IREDELL COUNTY HEALTH DEPARTMENT

Statesville Office (704) 878-5305 | Mooresville Office (704) 660-3625 | PERMIT # 223586

IMPROVEMENT PERMIT / AUTHORIZATION TO CONSTRUCT / OPERATION PERMIT / EXISTING SYSTEM

SOIL/SITE EVALUATION for ON-SITE WASTEWATER SYSTEM

INITIAL SITE SKETCH

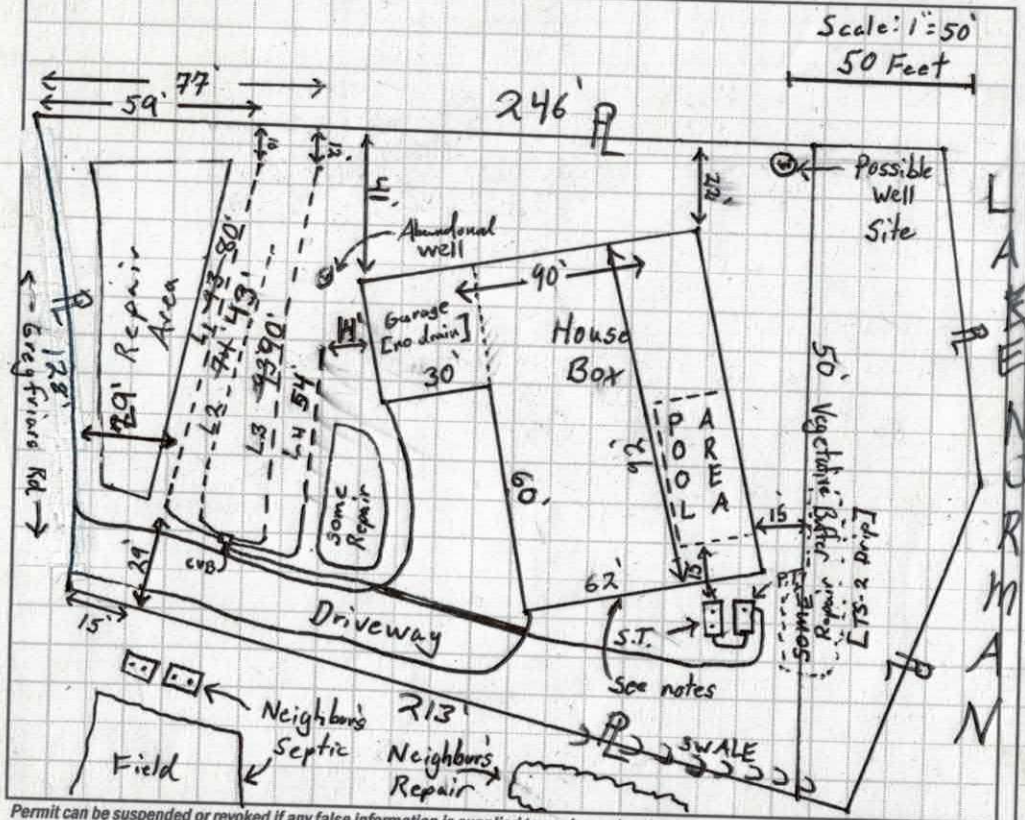
Comments / Conditions: Though 314 lf of line was laid out, only 267 lf need be installed. The remainder of the area shall be designated as repair. Septic + Pump tanks must be 15' from the foundation of the house if foundation drains are installed (due to side slope). If the driveway can be shifted towards the R and the drainfield lines L1, L2 + L3 lengthened to achieve 267 l.f., then only 3 lines need be installed. Remainder set aside as repair.
